The JFK Center: Is It in the Wrong Place?

Huge Size Would 'Overpower' Waterfront, AIA Official Says

Architect Edward Durrell Stone's plan for the Kennedy Center, as it would look from the river. Realization that it would be about the height of a 10 or 11 story building gives an idea of its size.

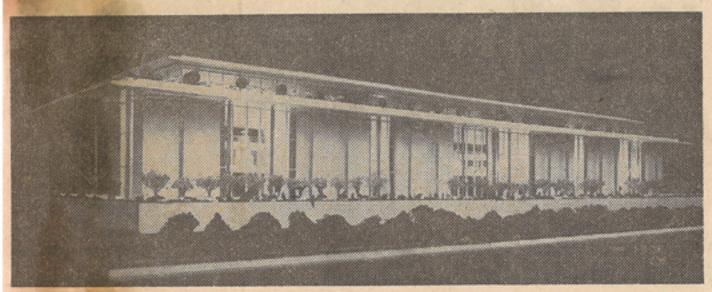
Mr. Satterlee, explaining the AIA's last-minute attempt to move the Center to downtown Washington, said it would "overpower and dominate the waterfront. . . . It is a perfect example of how not to site a building of its size and volume."

The Kennedy Center is a solid 690 feet long, 360 feet deep and 100 feet high - the height of a 10 or 11 story building.

It will sit right on the river bank, with the parkway moved to the river's edge. The northbound lane, in fact, would be shadowed by an overhanging roof of the center.

Architect Nicholas Satterlee prepared this scale drawing for The Washington Daily News showing the Dulles Airport terminal, shaded lines, superimposed on the Kennedy Center, to show the sizes of each. Blacked in at left is the first building of the Watergate development, an "amoeba" in comparison.

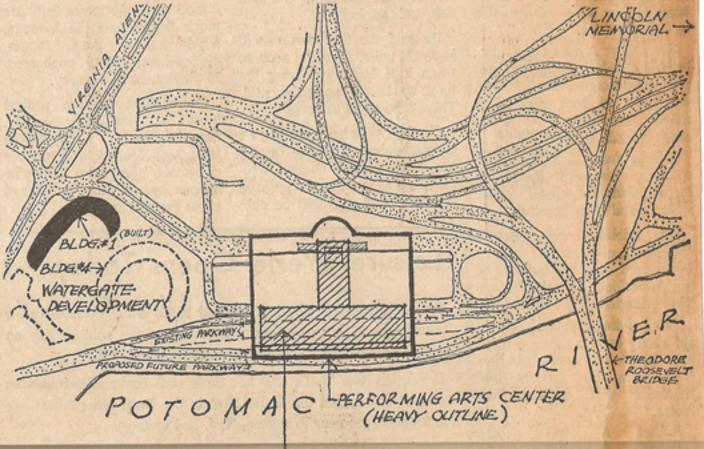
"But it's a little amoeba by comparison," Mr. Satterlee said. "And the Watergate is good site-planning."

Aside from the fact that the AIA and Mr. Satterlee contend that the Center is too far from the heart of the city and too hard for pedestrians to reach, hemmed in as it will be by freeways, Mr. Satterlee said it is just too big for the site.

It should be broken down, perhaps into a complex of smaller buildings, somewhat like Lincoln Center in New York, he said.
